City of Plymouth Planning Commission

Regular Meeting Agenda

**Special Land Use and
Site Plan Review
For
Plymouth, Michigan**

Applicant:	Bryan Bender Fortisnet Lease 30445 Northwestern Highway Farmington Hills, MI 48334
Project Name:	Scooter's Coffee Drive-Thru
Plan Date:	September 17, 2021
Location:	1490 W. Ann Arbor Road
Zoning:	ARC – Ann Arbor Road Corridor District
Action Requested:	Special Land Use and Site Plan Approval
Required Information:	Any deficiencies are noted in the report.

4 EXTERIOR ELEVATIONS
SCALE: 1/4" = 1'-0"

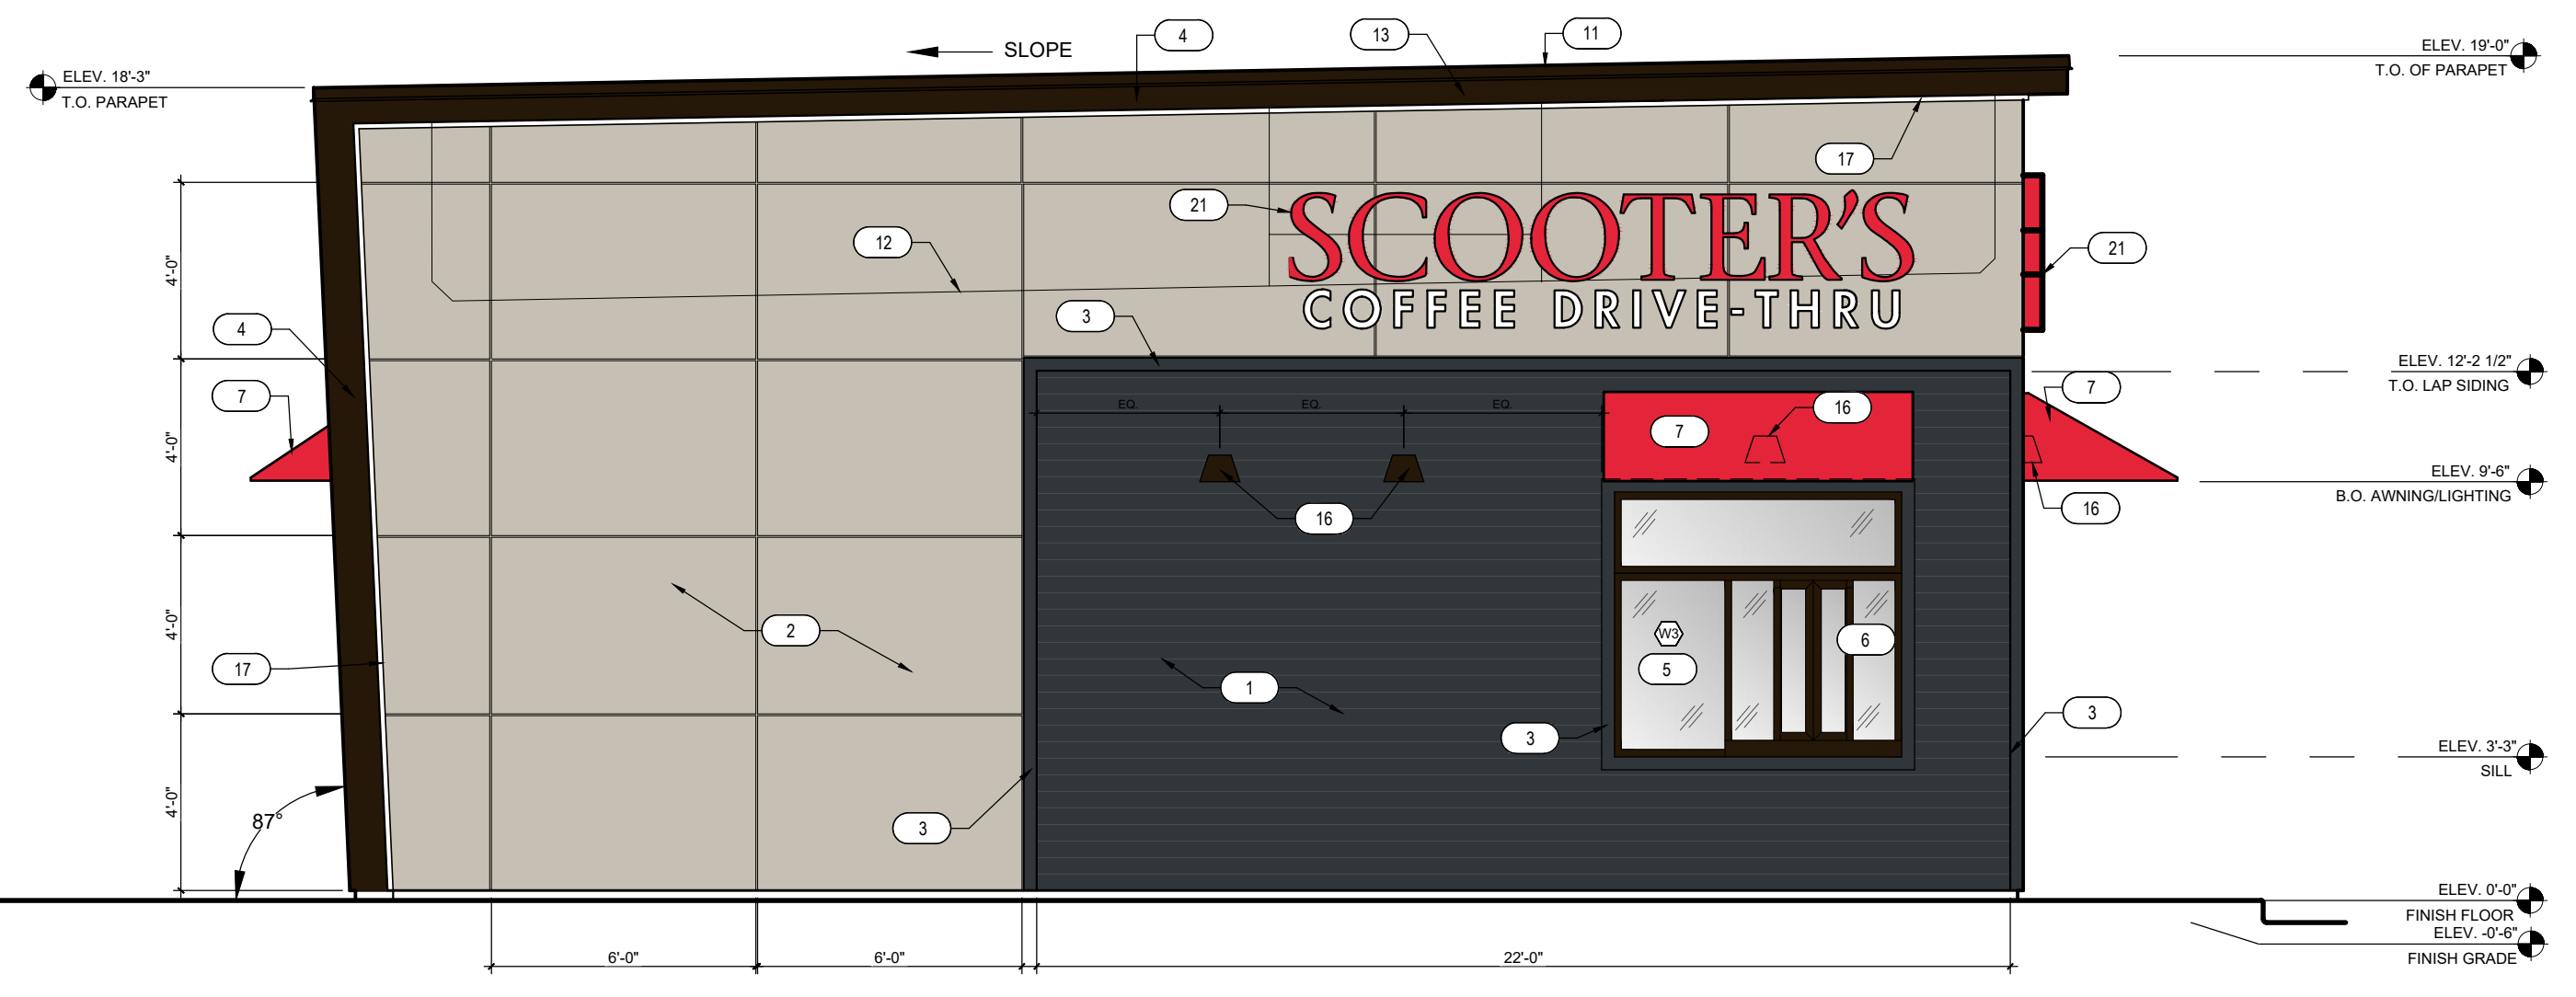
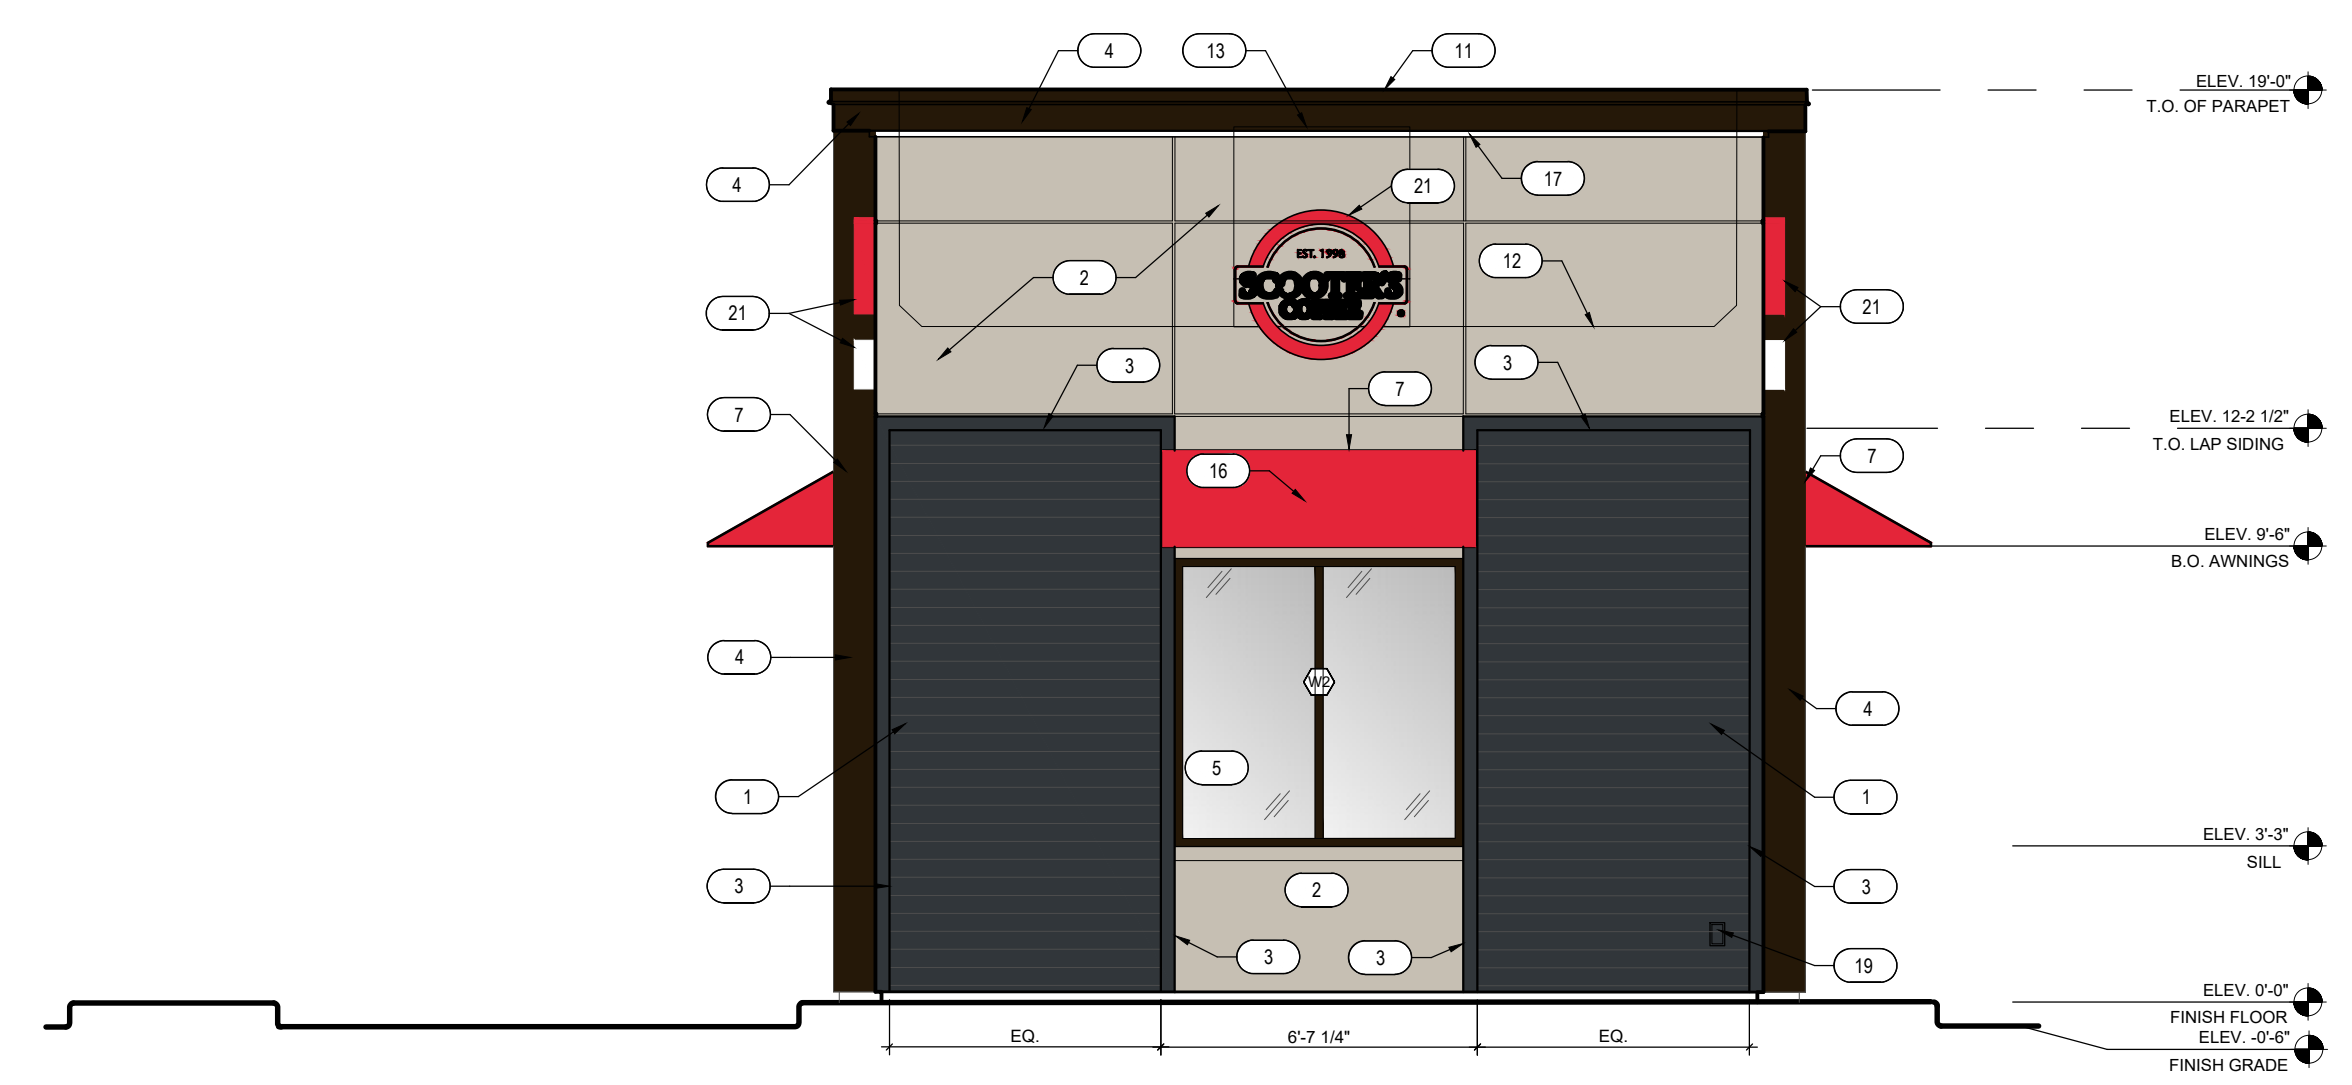
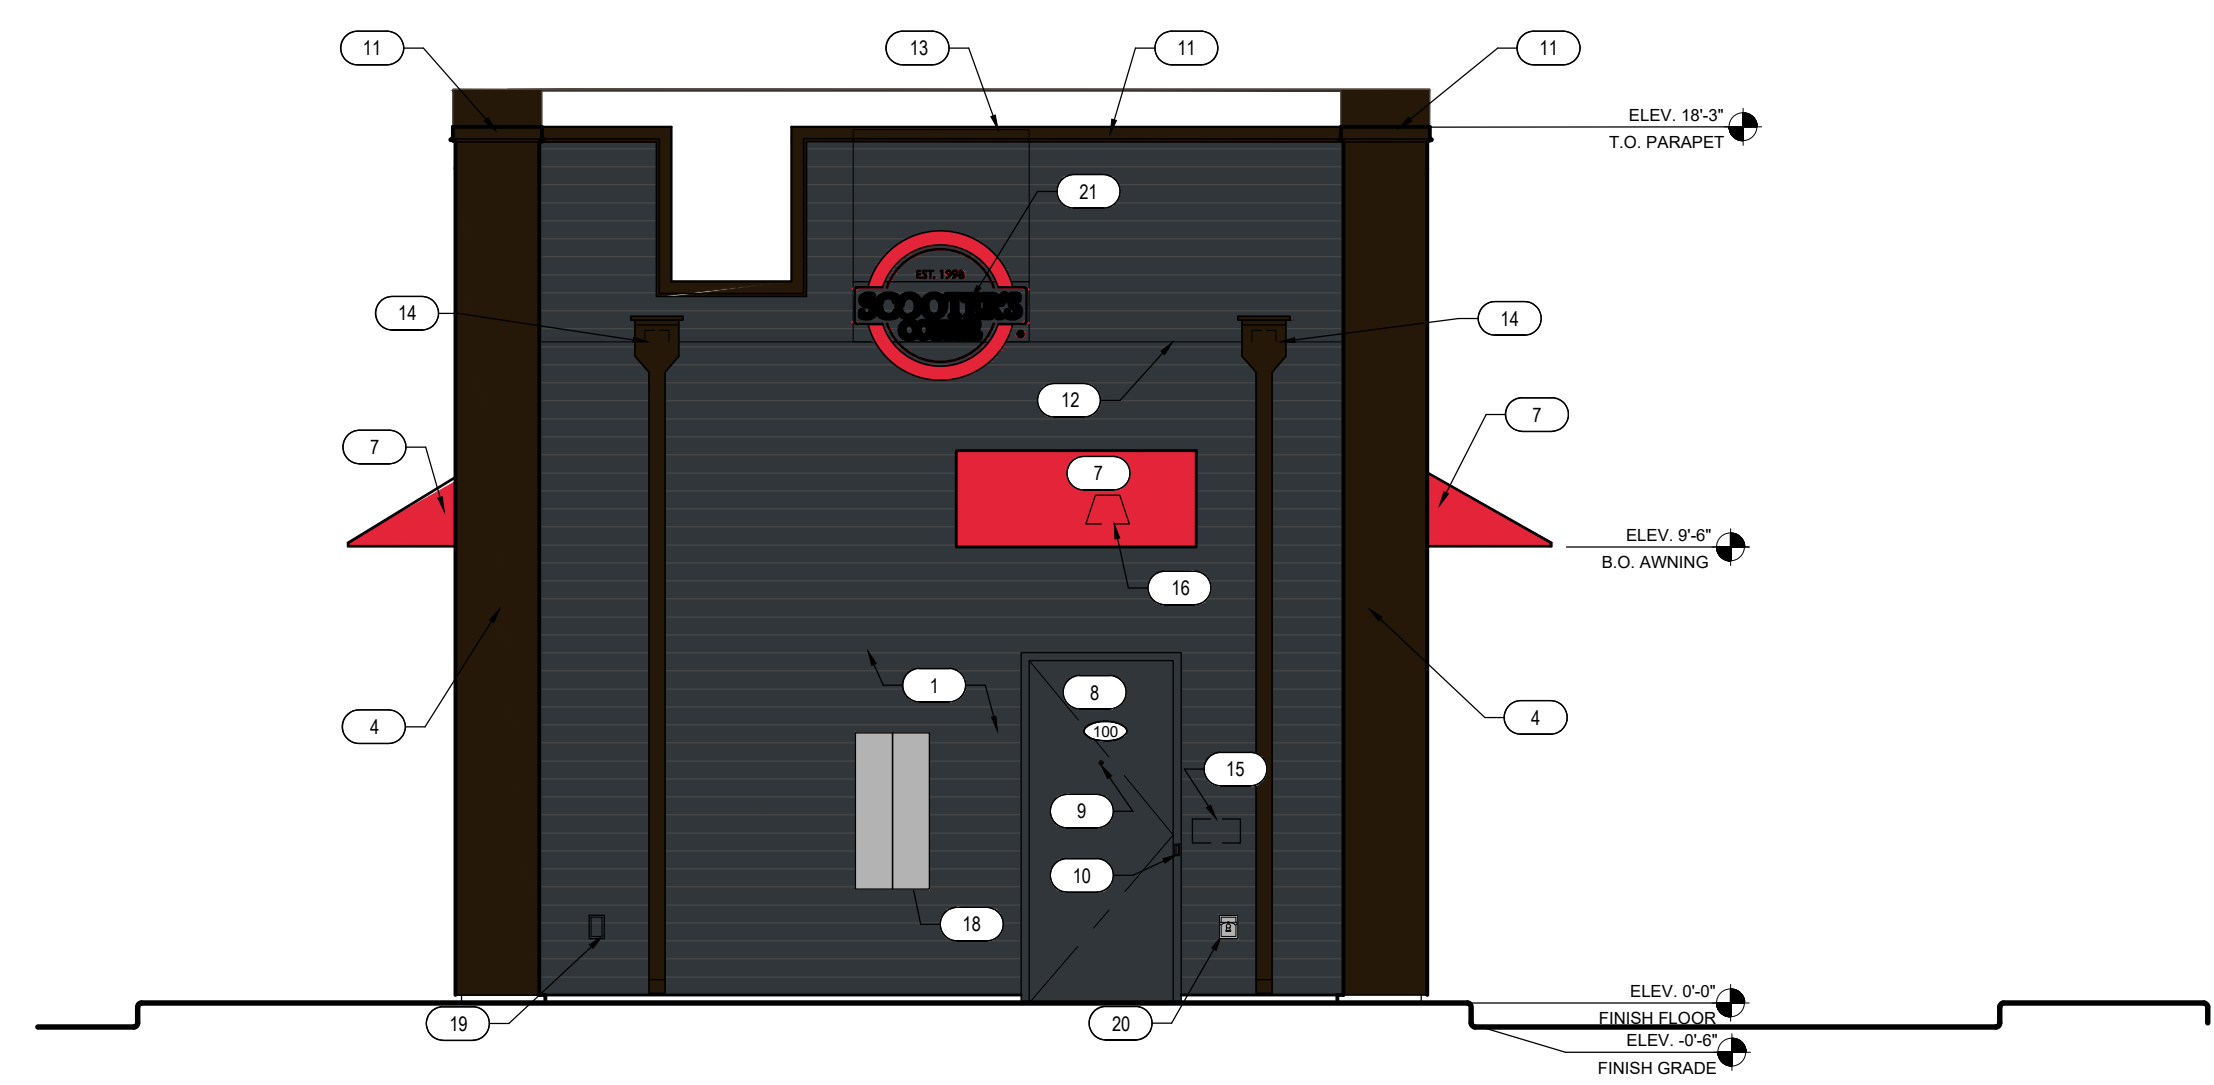
The building elevations show a corporate building design that is intended to brand this site and tie it specifically to this particular business. The ARC District has guidelines for building design specified in Section 78-161(d)(1)(f). It calls for the use of brick, stone, black wrought iron accents, peaked roof elements, building architectural detail to enhance door and window openings, and other elements approved by the Planning Commission. It also calls for a façade adjacent to property zoned or used as residential to be designed, treated, and finished in a uniform manner consistent with the exterior of the front of the building. We suggest that the Planning Commission and applicant discuss the option of a building design that is more universal, as well as the proposed north facade. See the photo below as an example that has some of the elements called for in the ARC District guidelines:

- a. The possibility of a more universal building design that better fits in with the existing character along the Ann Arbor Road Corridor, and whether the north façade has the same treatment as the front façade, as required.
- b. Planning Commission determination of a masonry screen wall (vs. wood fence) between the site and residential neighbors.
- c. Pedestrian service via a walk-up window.
